DOCUMENT 009113 - ADDENDA

- A. Addendum No. Two.

- A. Project Name: Skatium Locker Room Renovation.
- B. Owner: Township of Haverford.
- C. Owner's Representative: C.B. Development Services, Inc.
- D. Architect: BKP Architects.
- E. Date of Addendum: October 4, 2024

Skatium Locker Room Renovation
Responses to Bidder Questions and Written Identification of Modifications to Project Documents

G1 | **FIGURE SKATERS LOCKER ROOM PARTIAL PLAN 2**
1/4"=1'-0"

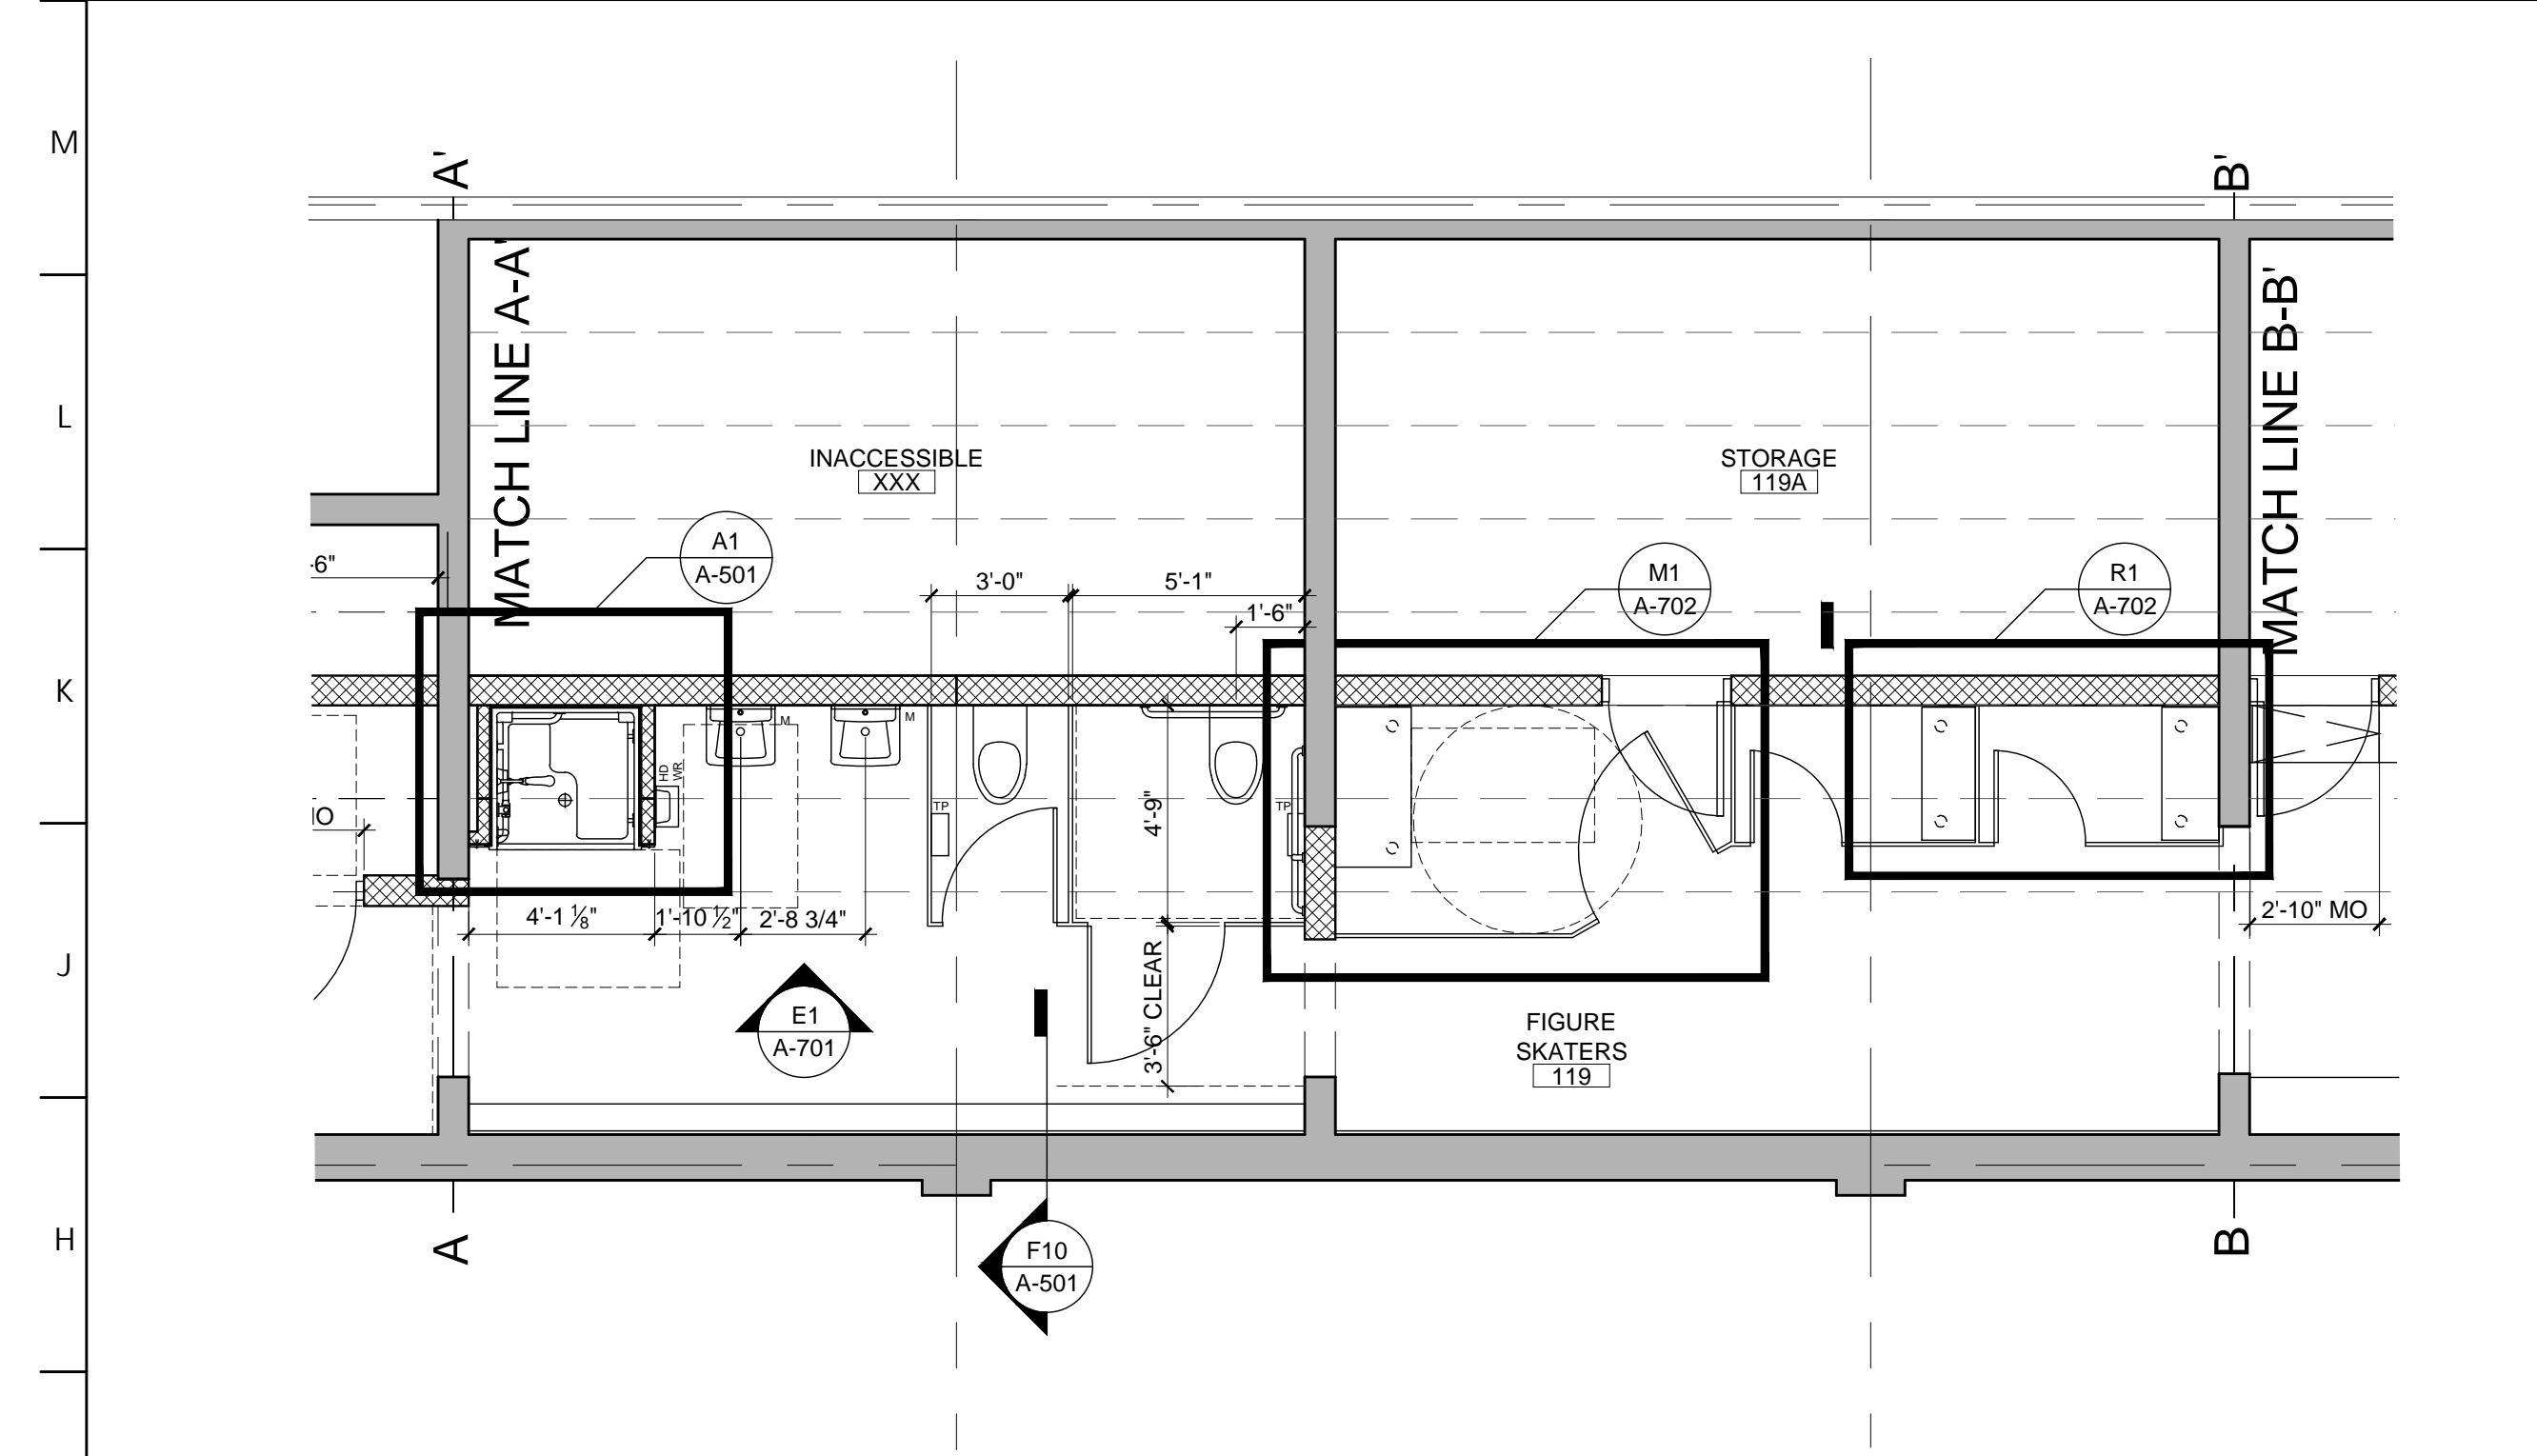
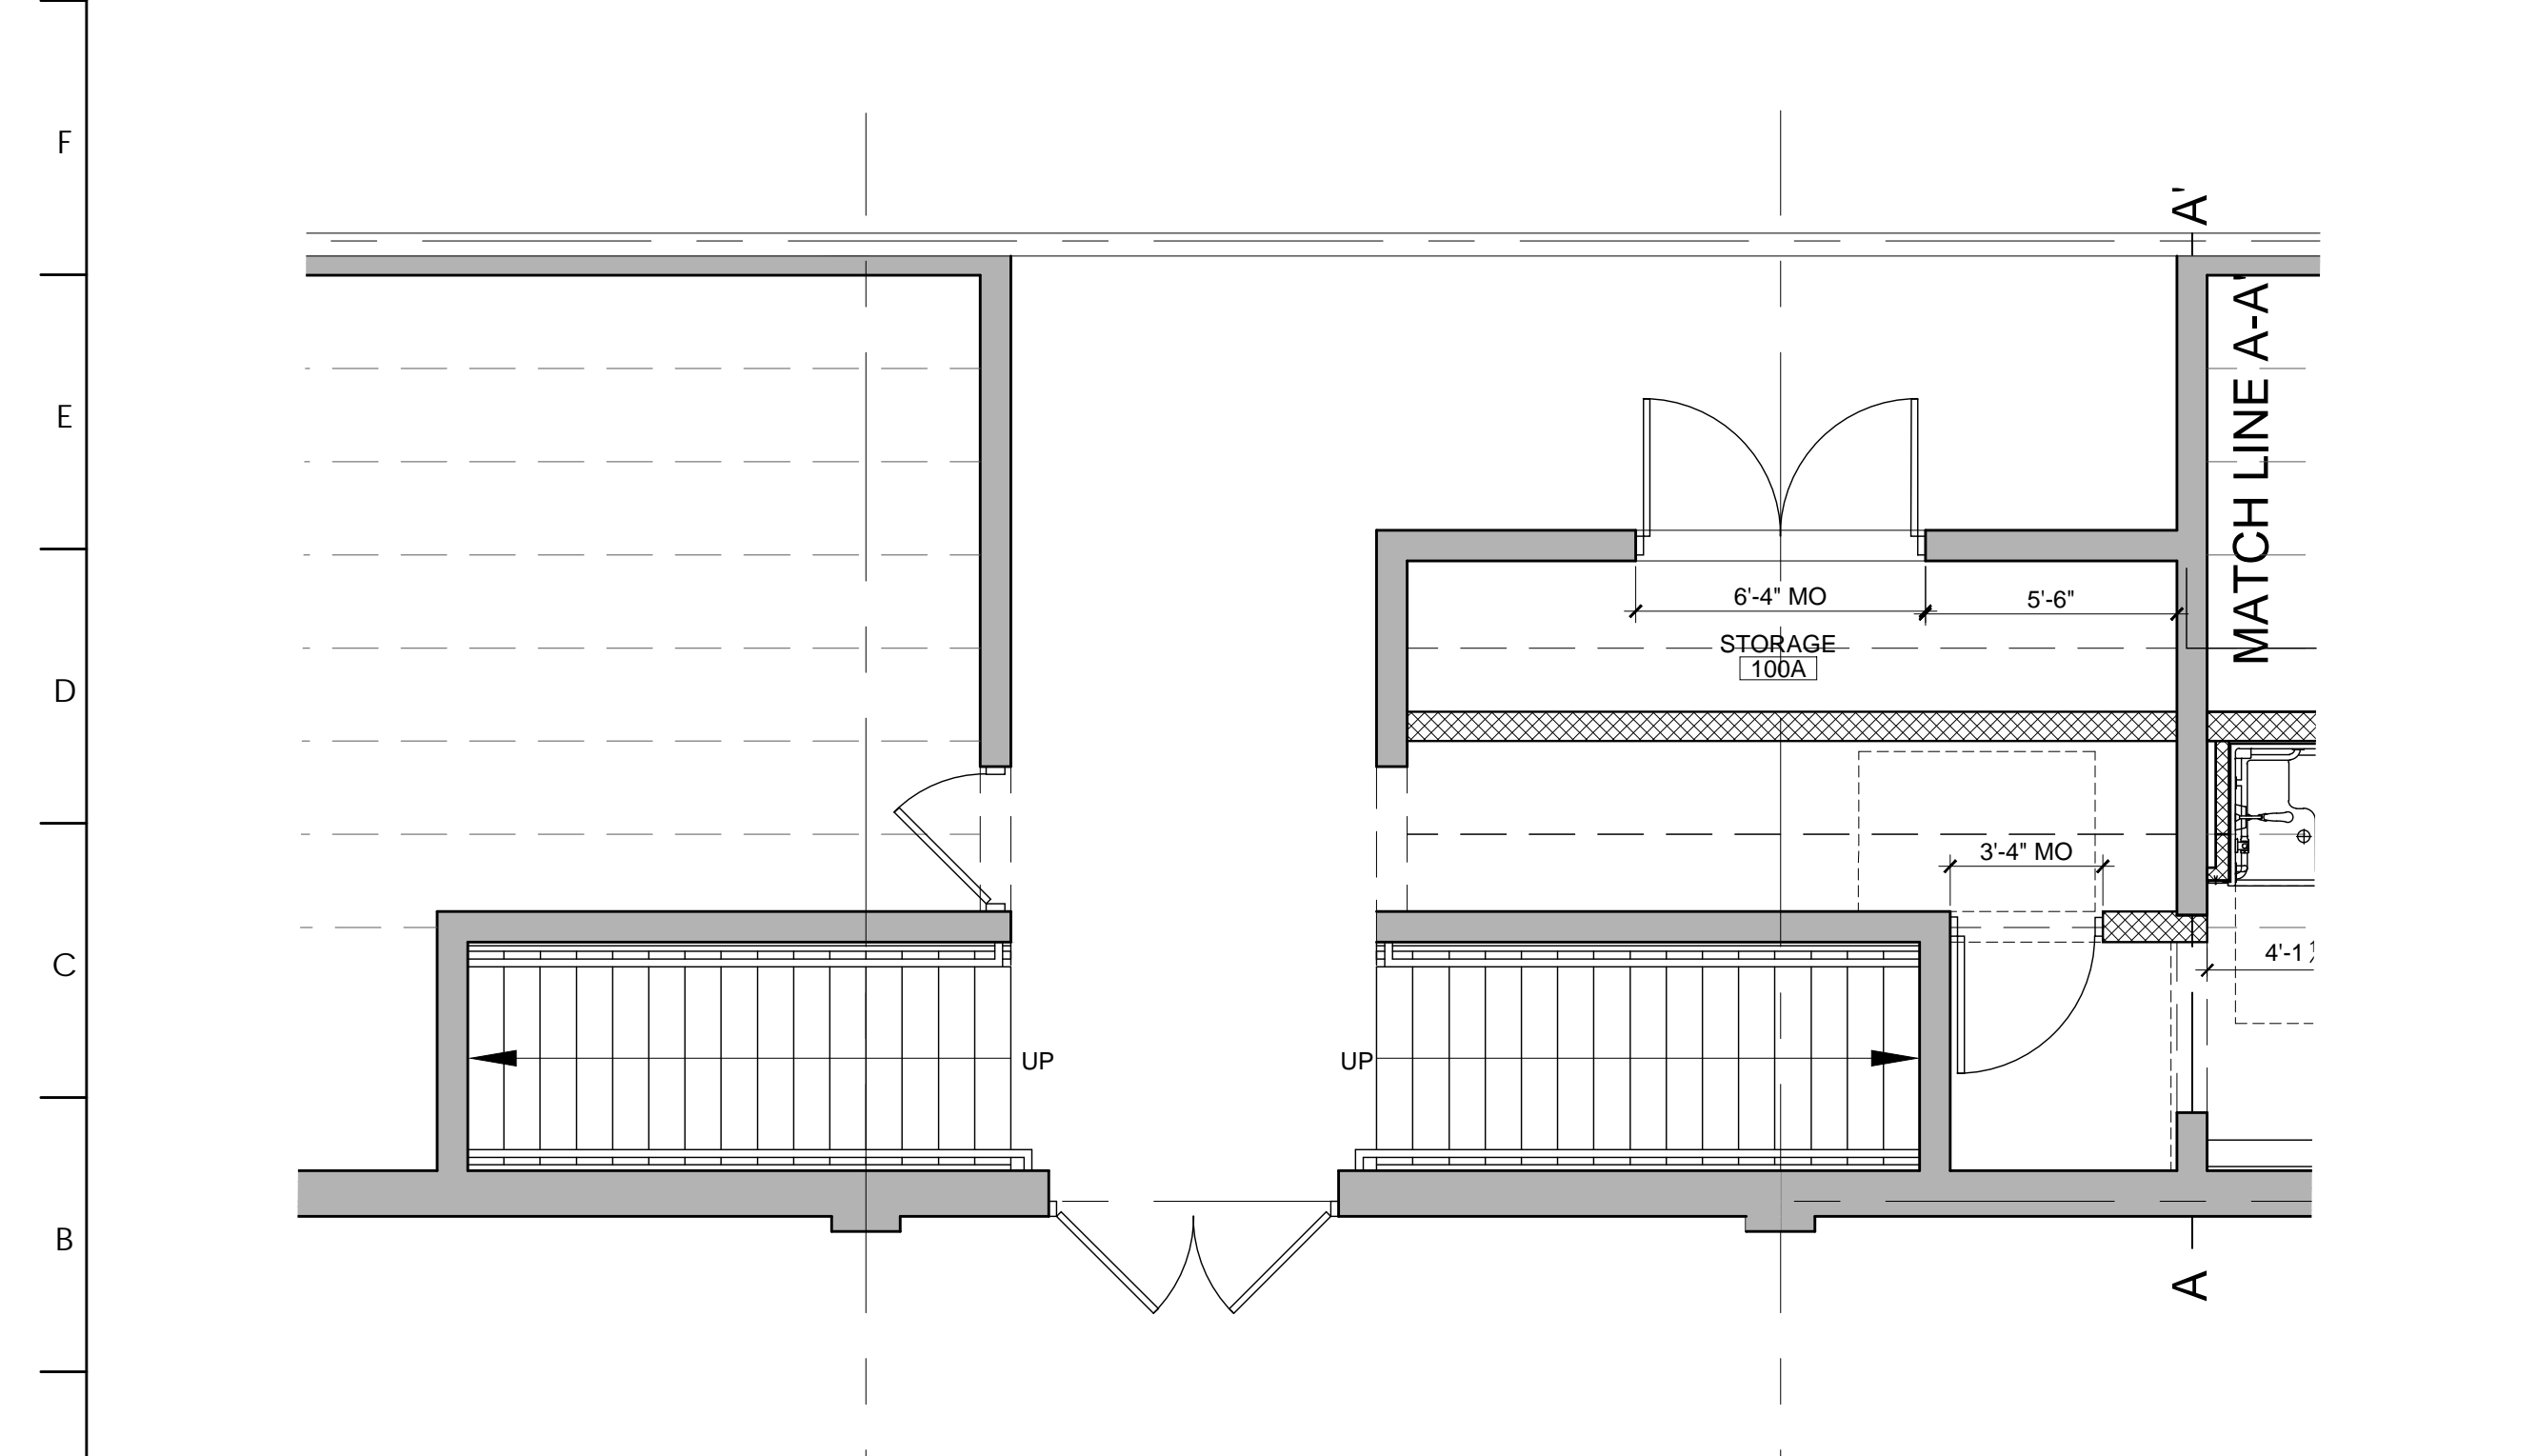
8. Several sheets reference Sheet A-100 which does not exist. Please advise.

- I. Drawing A-101 has been modified to include missing door hardware sets.
- J. Drawing A-601 has been modified, removing references to Sheet A-100, replaced with reference to Sheet A-701.

Reference to Sheet A-100 should have been A-701. Drawing sheets A-601 and A-602, which are affected by this change have been revised and issued with Addendum #2.
